From: BT
Sent: 18/02/2022 7:26:26 AM
To: Council Northernbeaches Mailbox
Cc: Garry & Susan Farrell; Avalon- Paul Minter
Subject: TRIMMED: DA 2022 0084 73 MARINE PARADE AVALON BEACH
NSW 2107 WRITTEN SUBMISSION: LETTER OF OBJECTION
FARRELL & MINITER
Attachments: 73 Marine.docx;

RE: DA 2022 0084 73 MARINE PARADE AVALON BEACH NSW 2107
WRITTEN SUBMISSION: LETTER OF OBJECTION
SUBMISSION: FARRELL & MINITER

The development application seeks approval for a new dwelling to replace the existing dwelling, add a granny flat above a garage and a swimming pool.

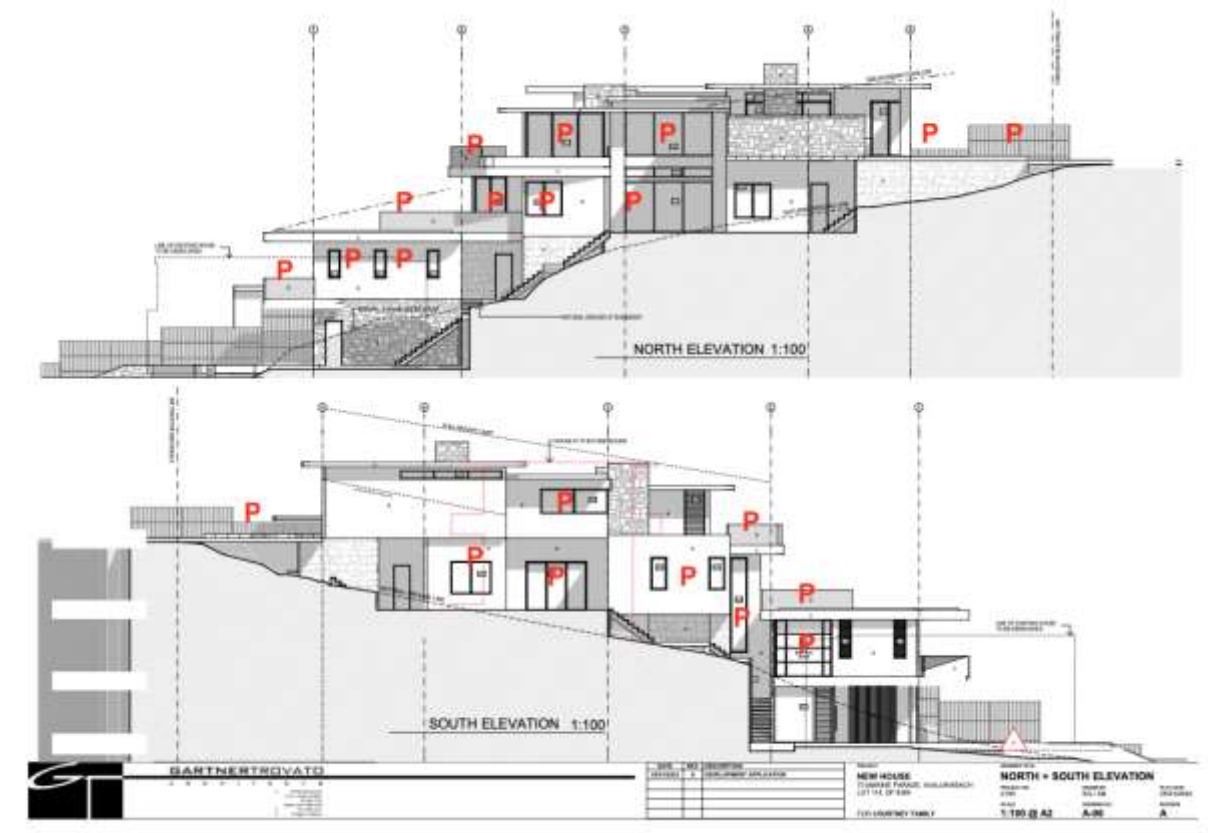
The same unreasonable scenario in Rebel applies to the current DA. The proposed dwelling will take away views from our property to the considerable benefit of the future occupants of the proposed dwelling. This scenario is not consistent with the principle of View Sharing enunciated by his Honour, Justice Moore in Rebel. The adverse View Loss from our property is one of the negative environmental consequences of the proposed development. The proposed development cannot be supported on visual impacts grounds.

Height Poles: We ask Council that after amended plans are submitted to reduce the building envelope to all envelope controls, to request that the Applicant position 'Height Poles/Templates' to define the building envelope, and to have these poles properly measured by the Applicant's Registered Surveyor. The Height Poles will need to define: All Roof Forms, and all items on the roof, Extent of all Decks, Extent of Privacy Screens. Height Poles required for all trees. The Applicant will have to identify what heights and dimensions are proposed as many are missing from the submitted DA drawings.

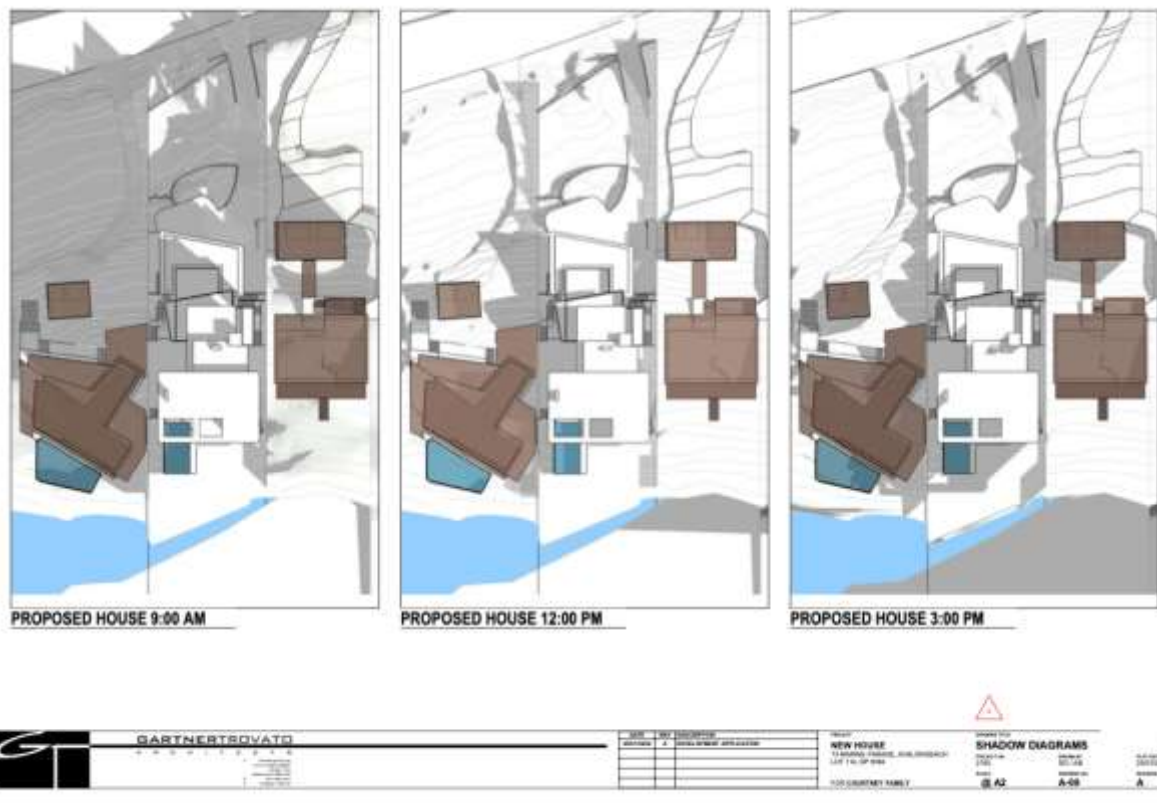
The proposed development will result in unreasonable overshadowing of the windows of our property and the private open space of our property, resulting in non-compliance with the provisions of DCP.

Our solar panels will also be heavily overshadowed in winter.

Diagrams show complete overshadowing of neighbour to the south from 9am to 3pm Winter, including north facing windows and north facing private open spaces, and solar collectors. Non-compliant building envelope on the southern boundary is contributing to this loss.

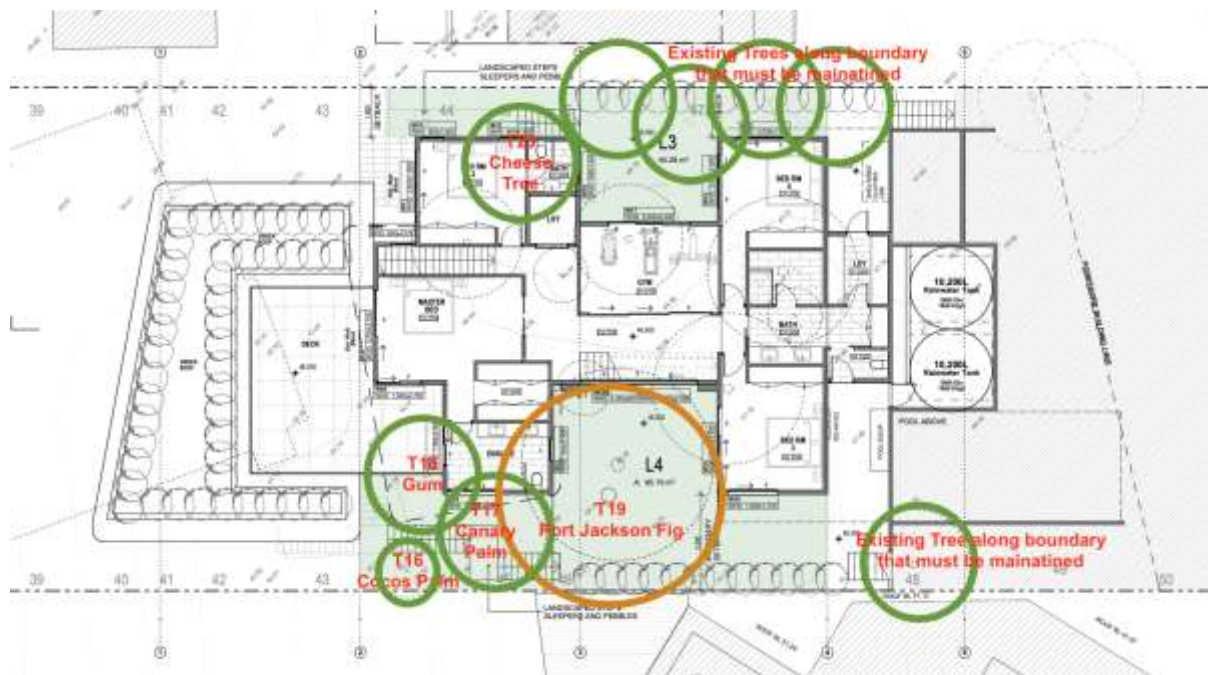
The proposed development does not provide sufficient landscaping, including 6m high privacy planting facing our property. The proposed development does not provide an adequate setback area which would permit the planting of appropriate vegetation which could offer visual screening.

The built form is not softened by landscaping, and does not provide adequate tree replacement to soften the built form.

The landscaped area as shown in the Landscape Plans proposes tree planting in areas considered to inadequately provide spatial dimensions, with insufficient soil depth, to support long term tree growth.
